**APPLICATION FOR
URBAN DESIGN COMMISSION
REVIEW AND APPROVAL**

PROJECT ADDRESS: PHASE I- 800 North Block, East Washington Avenue (802, 854; Block 143)

Galaxie Phase I

Design Progression Items:

**NORTH LIVINGSTON ELEVATION
COMPARISON OVERLAY**

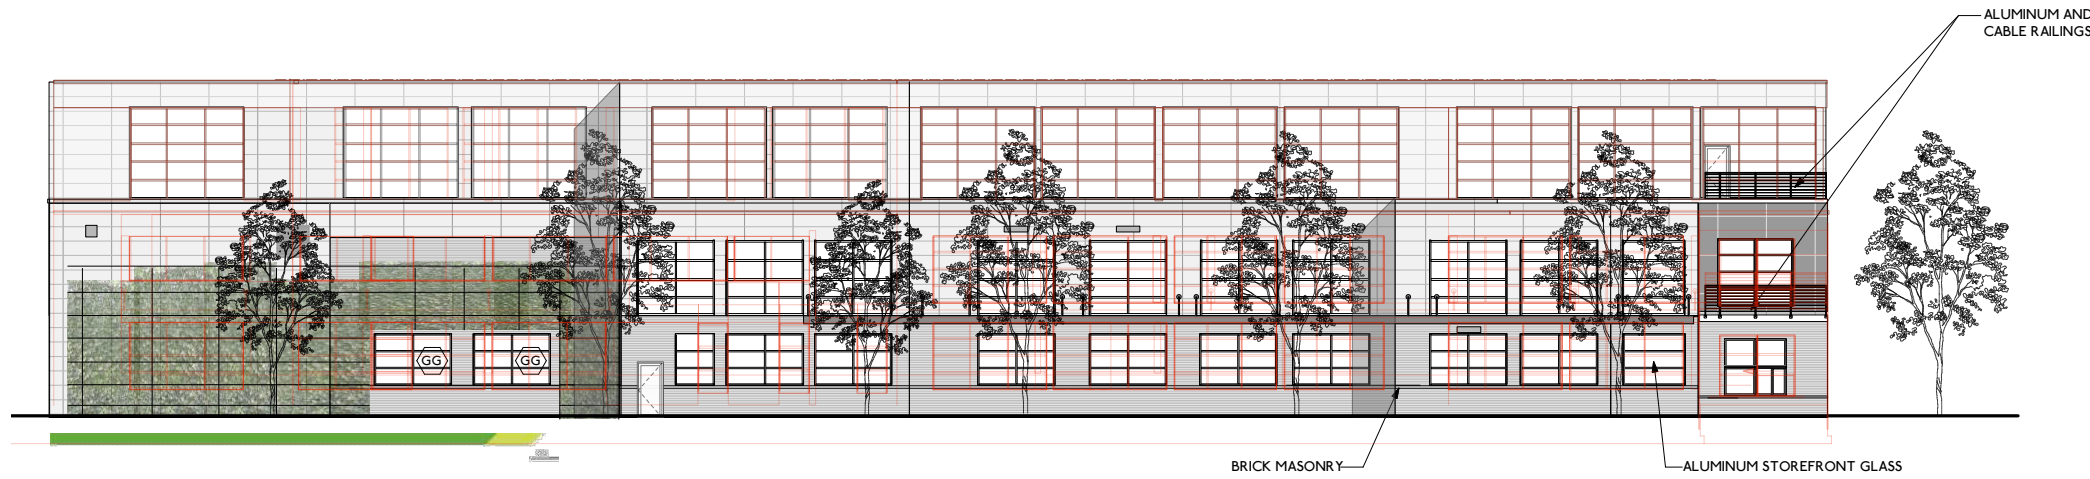
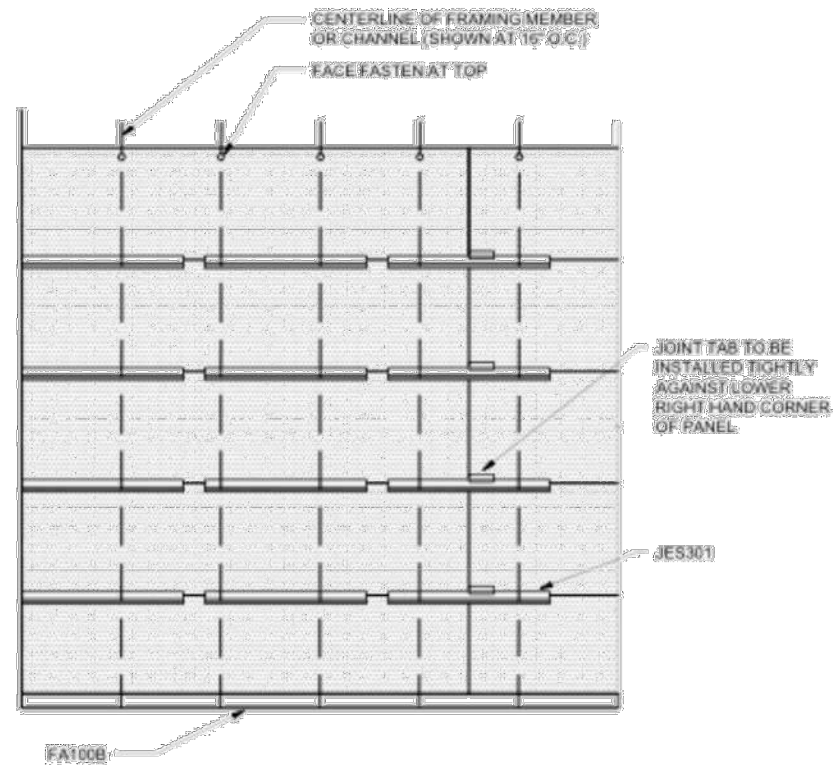
- 4: Reconfigure narrow Windows at East Washington entry
Reason: Anchor Tenant request
- 5: Delete Window at N. Livingston
Reason: Anchor Tenant request
- 6: Add Landscape trellis along N. Livingston
Reason: Roof Farm request

PLANTINGS TO INCLUDE EDIBLE BERRIES, BRAMBLES, LEGUMES, EDIBLE FLOWERS, GRAPE VINES, STRAWBERRIES

PANEL DETAILS
NO EXPOSED FASTENERS

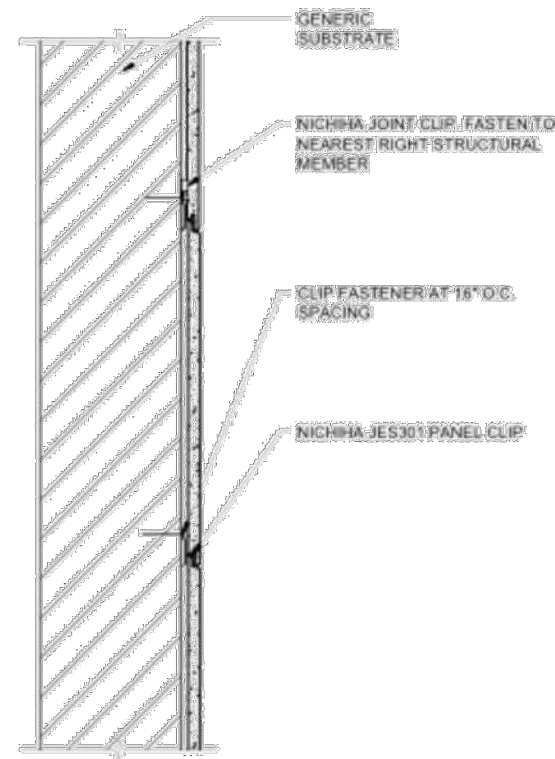
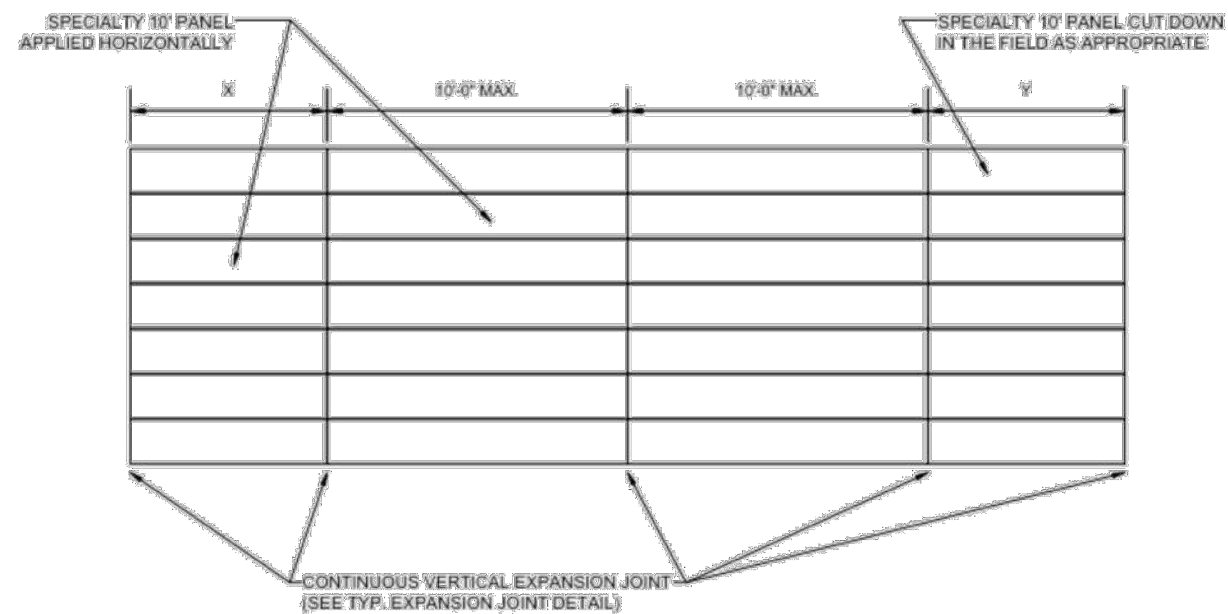
- 7: Substitute Composite panel
Reason: Architect request- supplier and installer deficiencies for previously sourced product
- 8: Minor window spacing changes
Reason: Several: Implementation of Whole trees for Grocery framing necessitated additional structural elements; program functions of grocery store, fewer obstructions of East Washington primary windows; structural components of Grocery mezzanine at Livingston
